9402240267 940214 PDR ADDCK 05000382 P PDR

WATERFORD UNIT 3

NPF-38-150

ATTACHMENT B

FIGURE 5.1-3 SITE BOUNDARY FOR RADIOACTIVE GASEOUS AND LIQUID EFFLUENTS

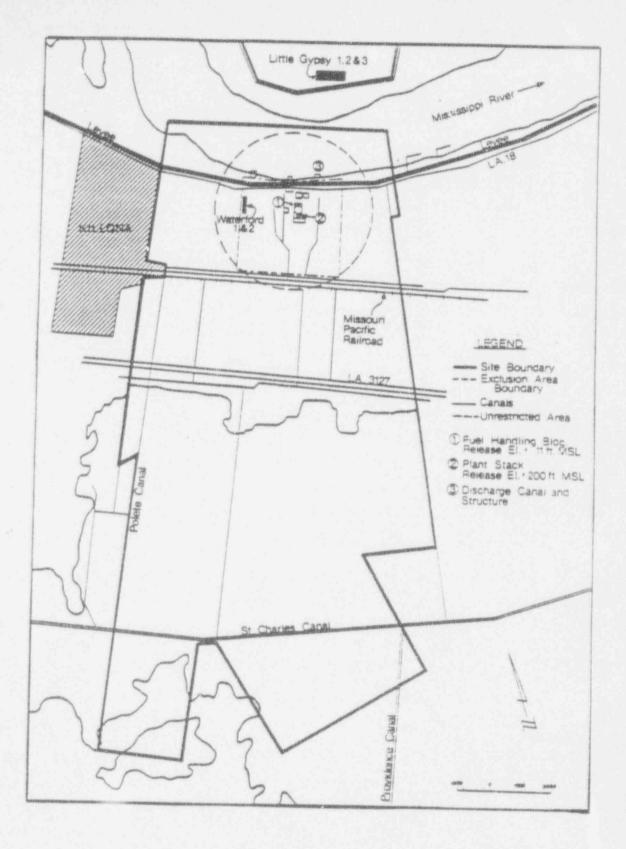
5.1.3 Information regarding radioactive gaseous and liquid effluents, which will allow identification of structures and release points as well as definition of UNRESTRICTED AREAS within the SITE BOUNDARY that are accessible to MEMBERS OF THE PUBLIC, shall be as shown in Figure 5.1-3.

AND LIQUID EFFLUENTS

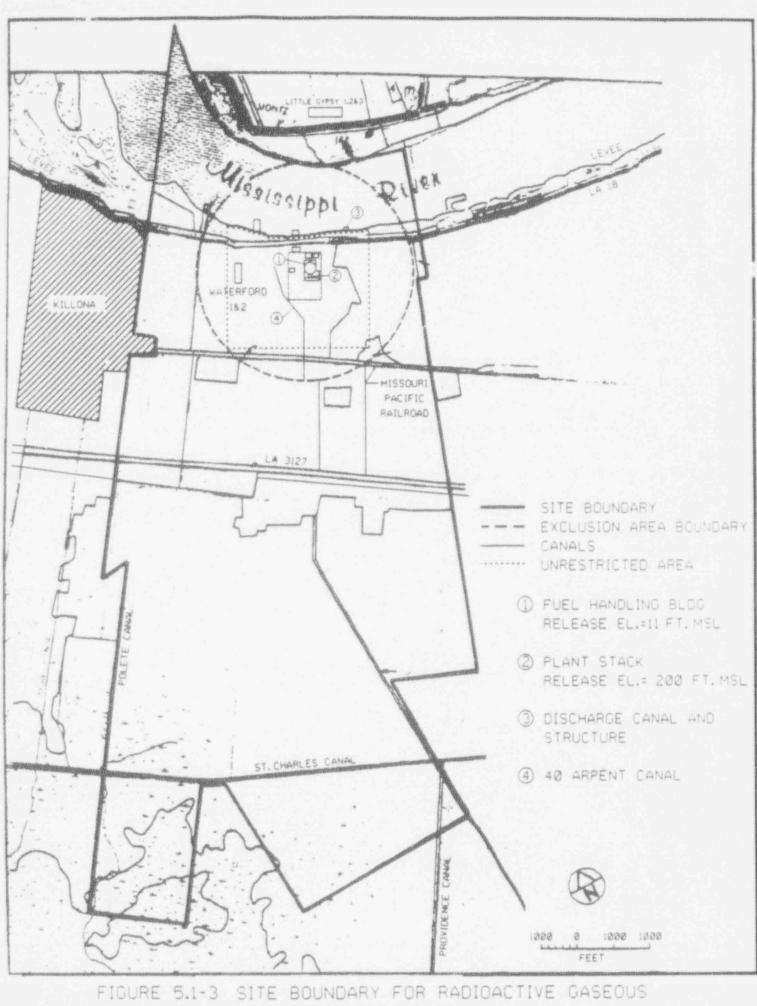
5.1.3 Information regarding radioactive gaseous and liquid effluents, which will allow identification of structures and release points as well as definition of UNRESTRICTED AREAS within the SITE BOUNDARY that are accessible to MEMBERS OF THE PUBLIC, shall be as shown in Figure 5.1-3.

The definition of UNRESTRICTED AREA used in implementing these Technical Specifications has been expanded over that in 10 CFR 20.1003. The UNRESTRICTED AREA boundary may coincide with the Exclusion (fenced) Area boundary as defined in 10 CFR 100.3(a), but the UNRESTRICTED AREA does not include areas over water bodies. For calculations performed pursuant to 10 CFR 50.36a, the concept of UNRESTRICTED AREAS, established at or beyond the SITE BOUNDARY. is utilized in the Controls to keep levels of radioactive materials in liquid and gaseous effluents as low as if reasonably achievable.
